ADDENDUM
NO. 2

July 23, 2020

Additions & Renovations to Lawrence North High School
7802 Hague Road
Indianapolis, IN 46256

ADDENDUM NO. 2
JULY 23, 2020

A. **Drawing Numbers CE101-CE104, CE106**

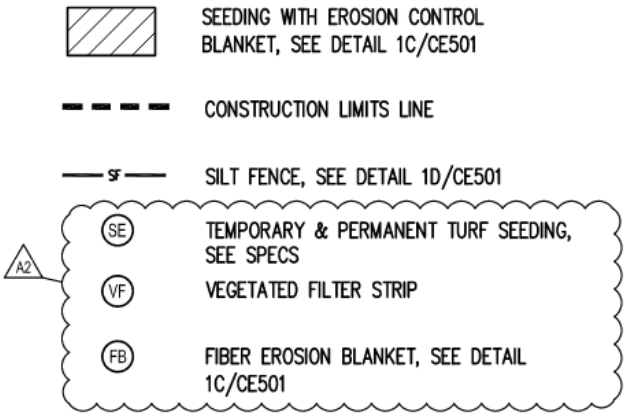
Revise EROSION CONTROL LEGEND to add keynote symbols as indicated below:

A. **Drawing Number SF1A2**

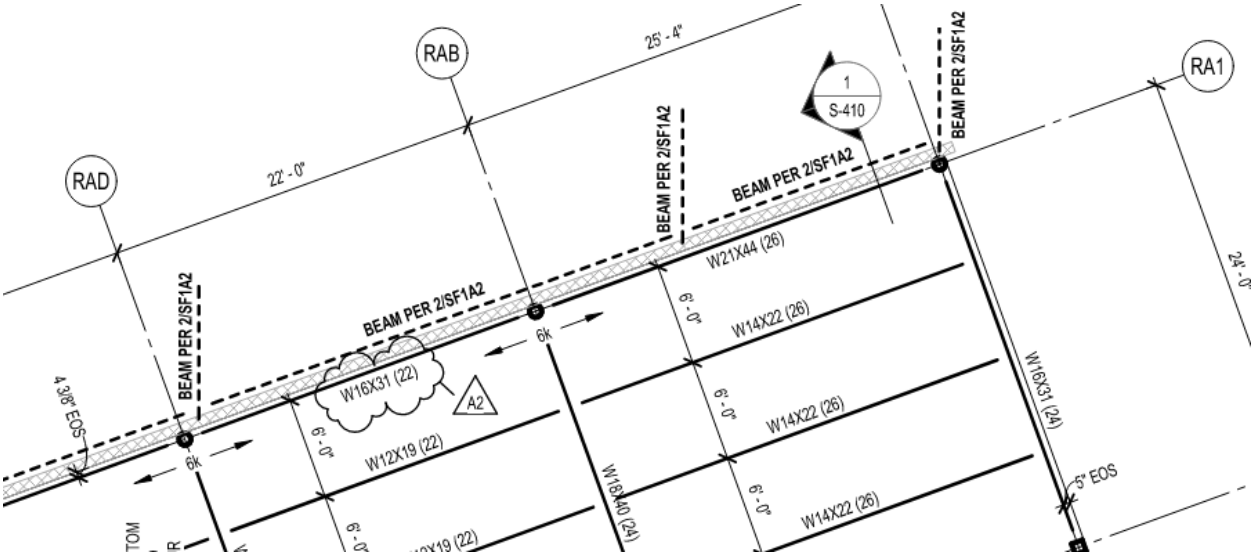
1. In 1/SF1A2, change the size of the beam between columns RAB-RA1 and RAD-RA1 to W16x31, as shown below:

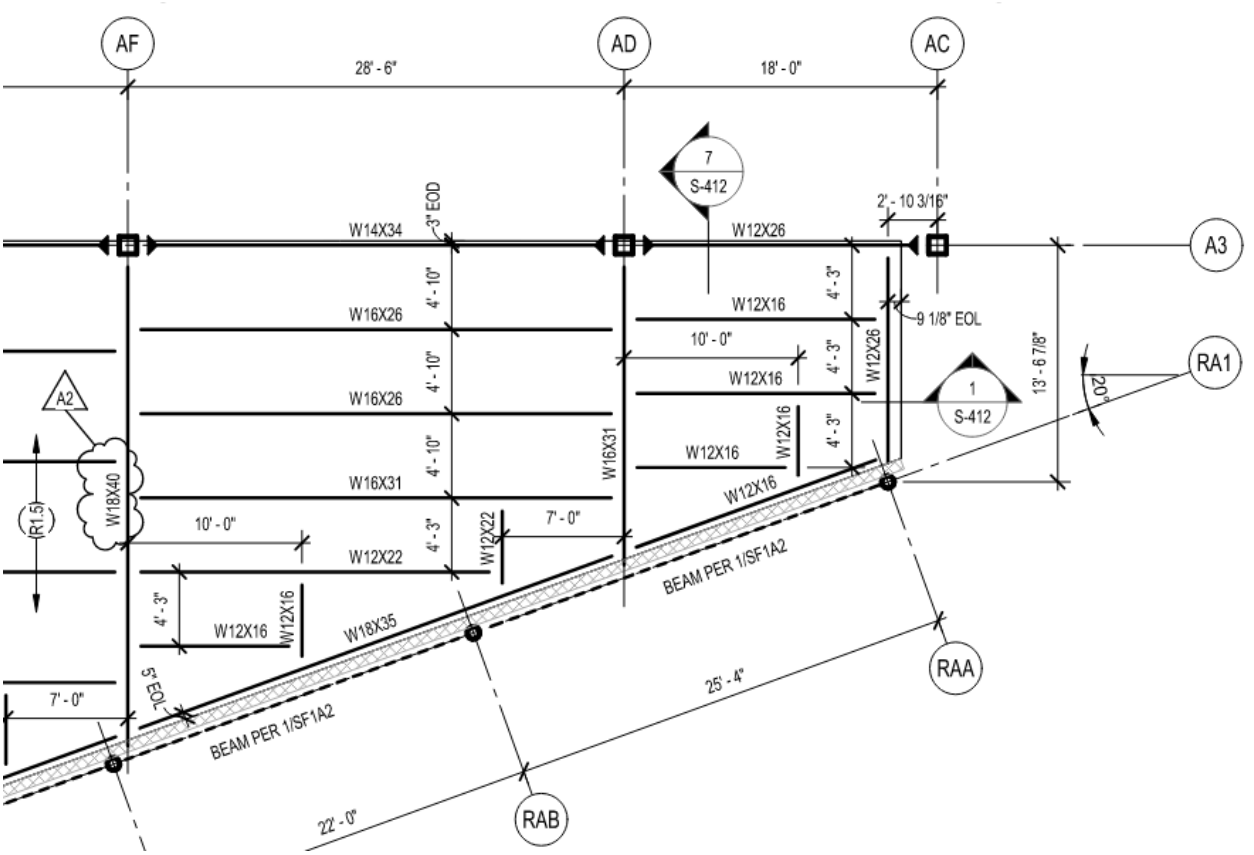
2. In 2/SF1A2, change the size of the beam south of AF-A3 to W18x40, as shown below:

A. **Drawing Number MDH1E1**

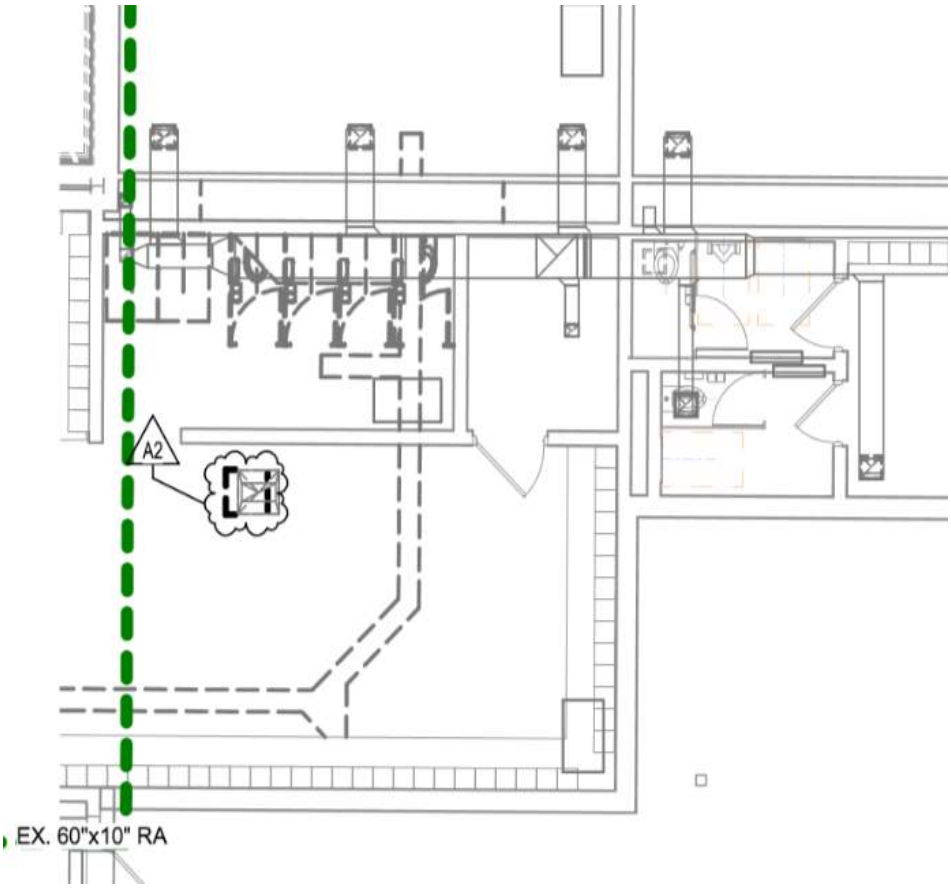
1. Delete roof mounted exhaust fan as shown below:

C. **Drawing Number MD401**

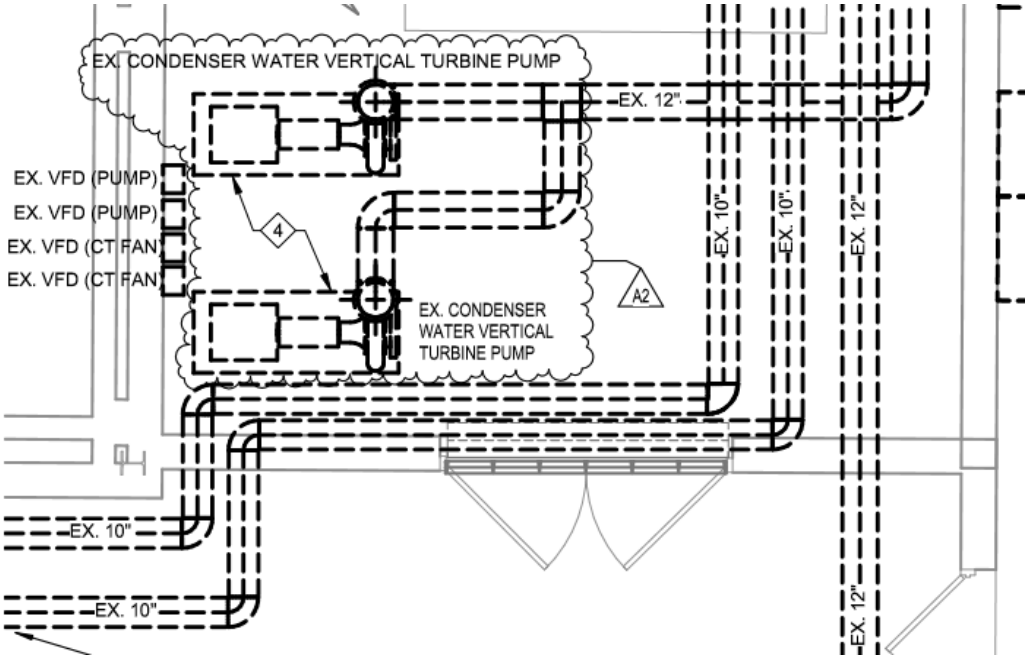
1. Delete vertical turbine pumps as shown below:

D. **Drawing Numbers MH1AB & MH1C1**

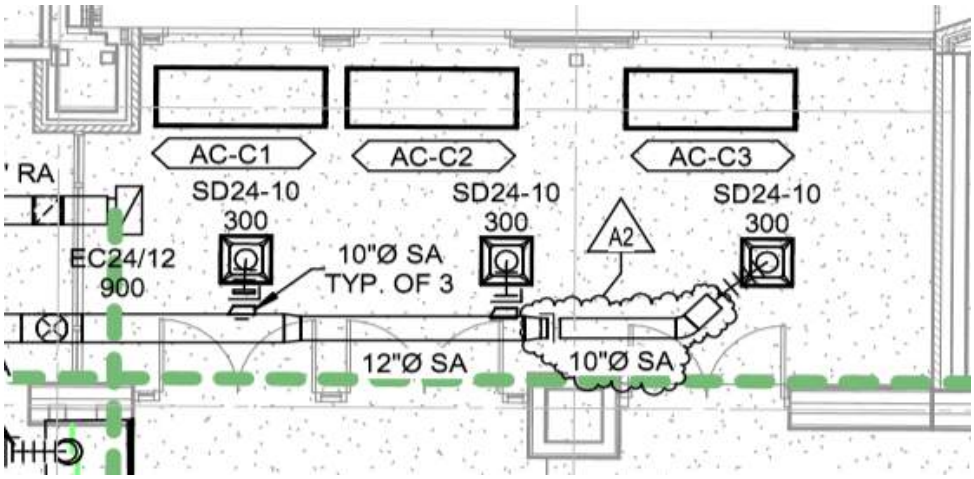
1. Revise duct size as shown below:

E. **Drawing Number MH1G2**

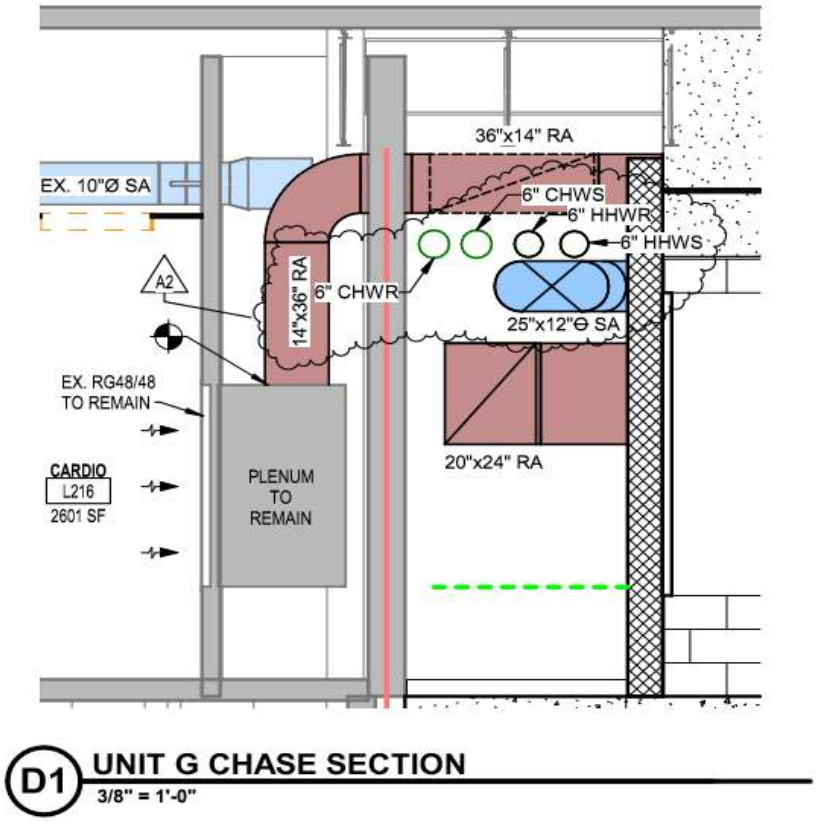
1. See revised Unit G Chase Section as shown below:

F. **Drawing Number MH1H1**

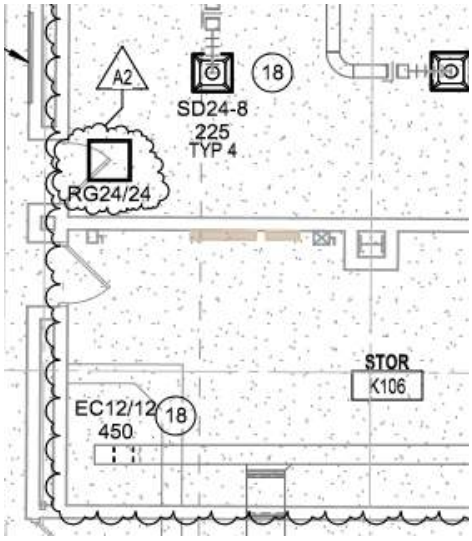
1. See return air grille information as shown below:

G. **Drawing Number MP1D1**

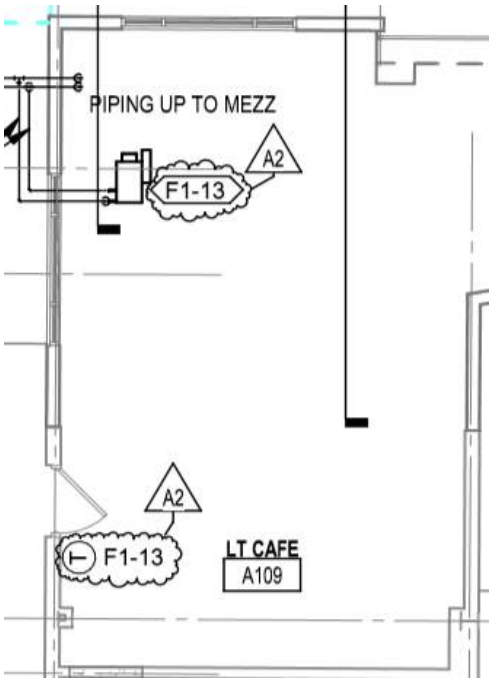
1. Provide VAV box tag & Thermostat as shown below:

I. **Drawing Number M-404**

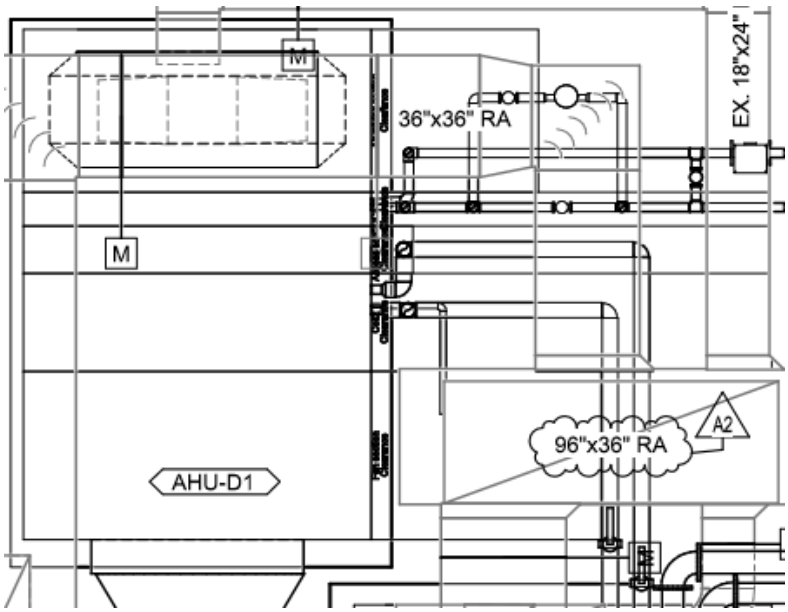
1. Provide duct size as shown below:

J. **Drawing Number M-404**

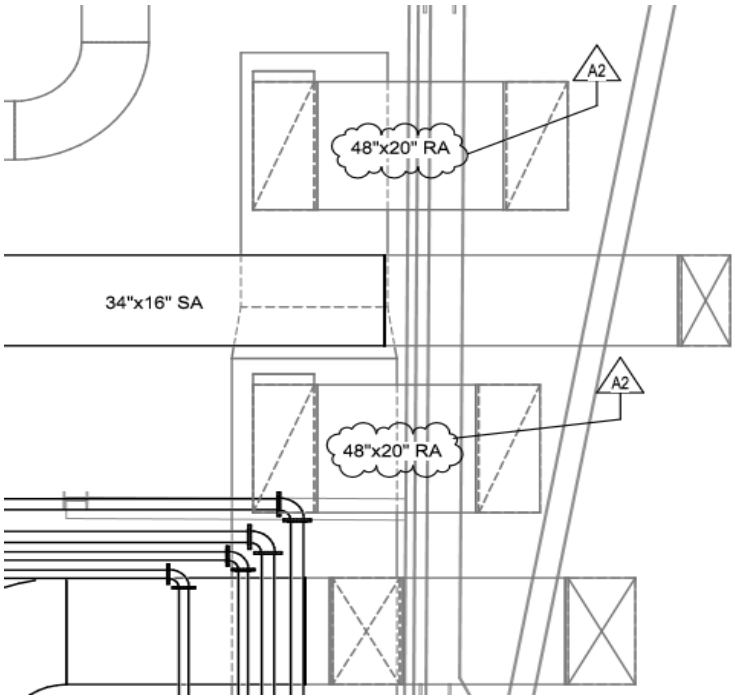
1. Provide duct size as shown below:

K. **Drawing Number M-501**

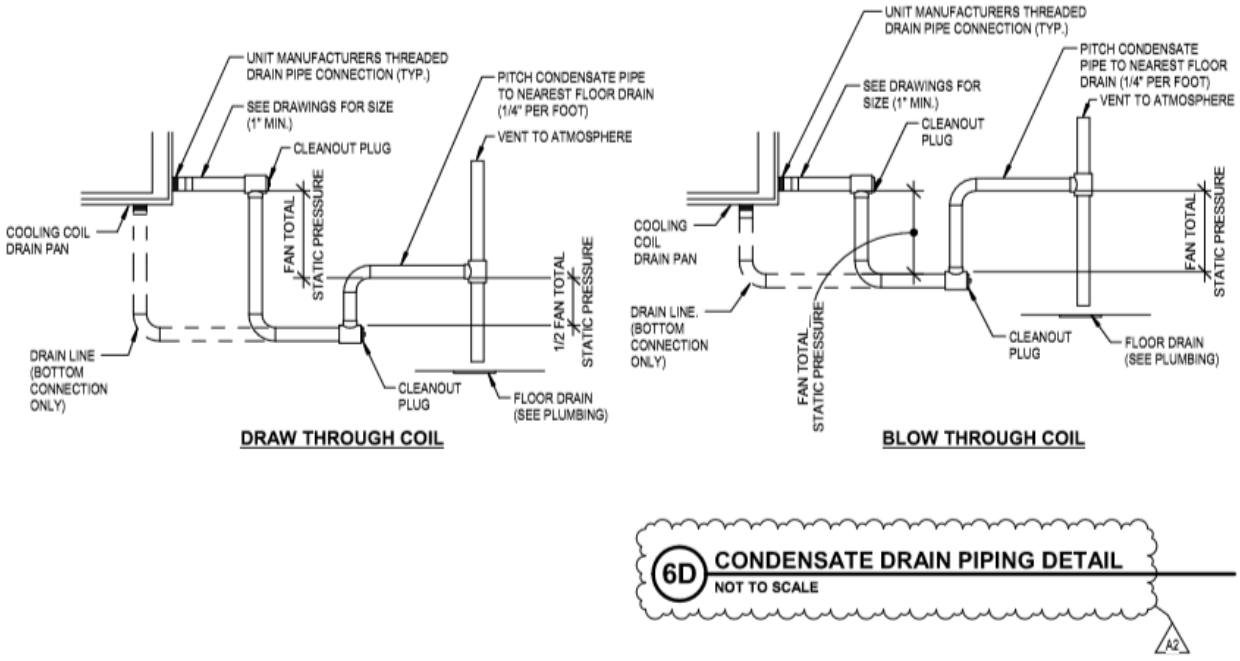
1. Provide Condensate Drain Piping Detail 6D/M-501 as shown below:

A. **Drawing Number PD1F2**

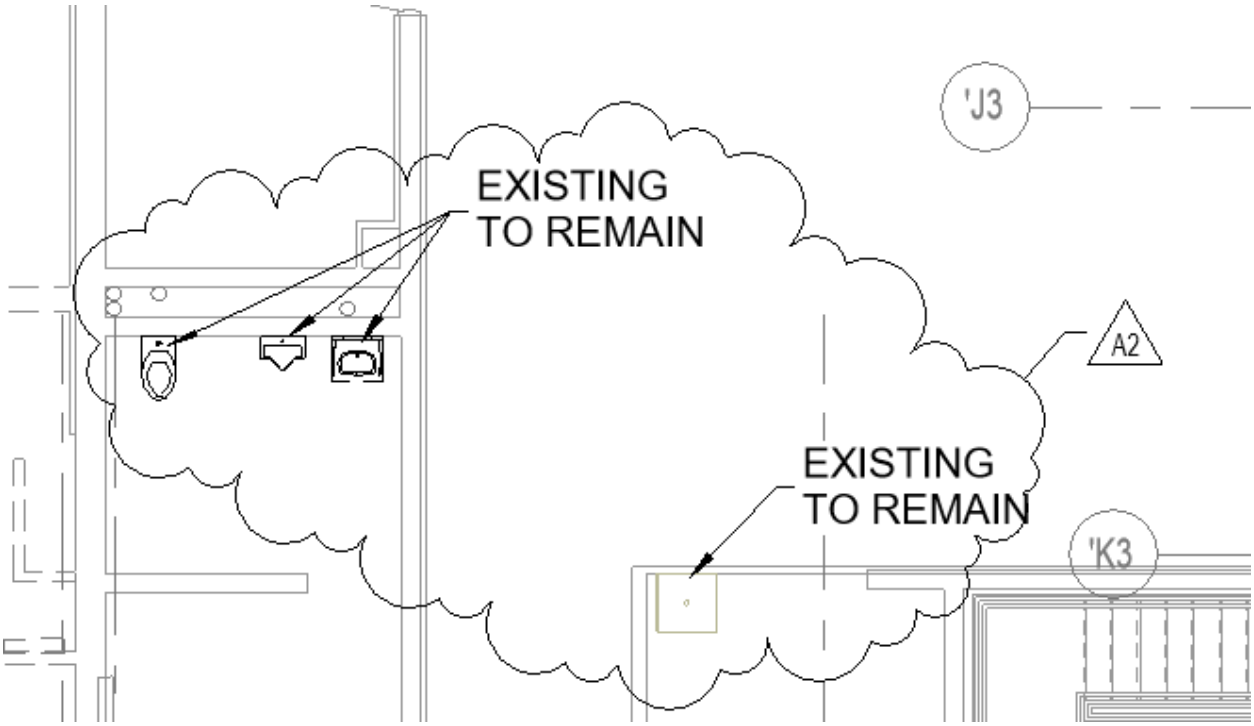
1. MODIFY Drawing as shown below:

"EXISTING TO REMAIN PLUMBING FIXTURES WERE NOT SHOWING UP ON THE PLAN."

D. **Drawing Number EL101**

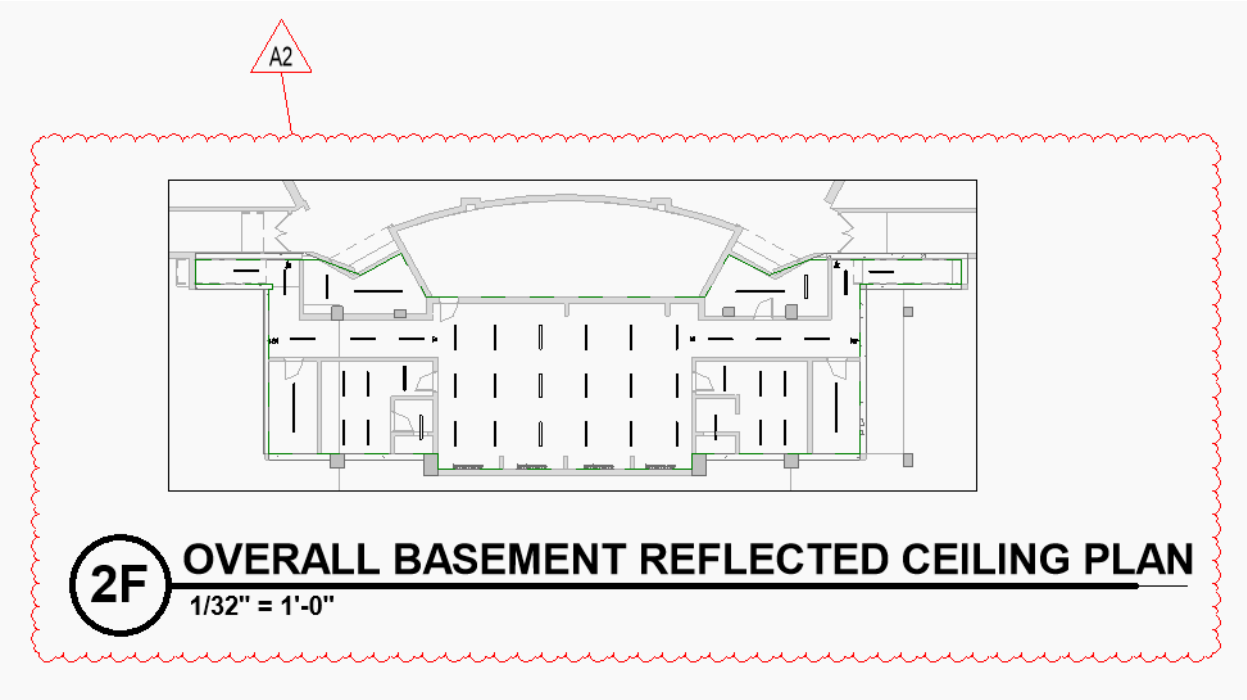
1. ADD Plan 2F/EL101 as shown below:

E. **Drawing Number EL1C1**

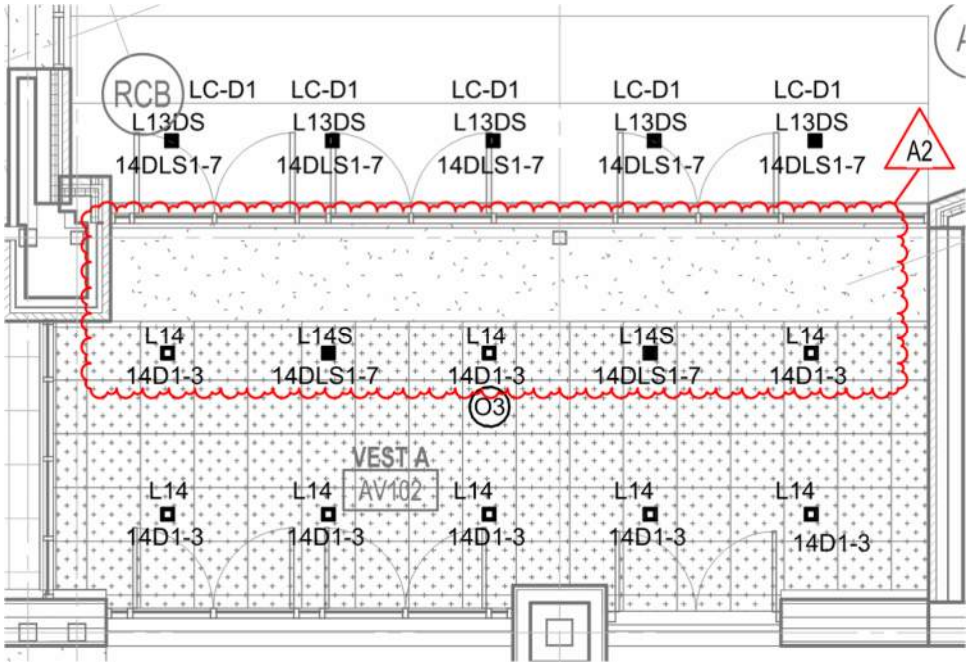
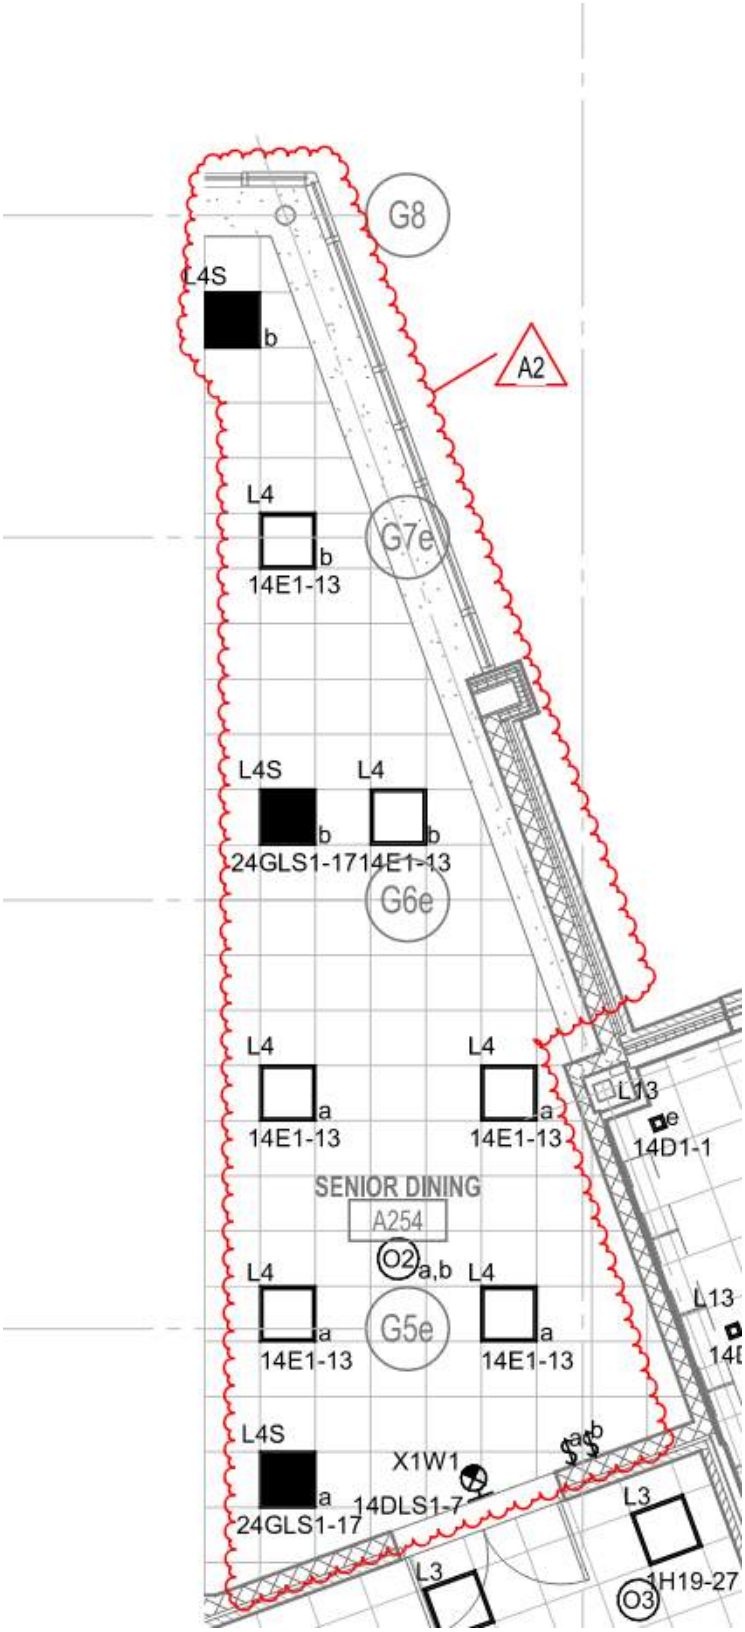
1. MODIFY Plan 1A/EL1C1 First Floor Lighting Plan – Unit C as shown below:
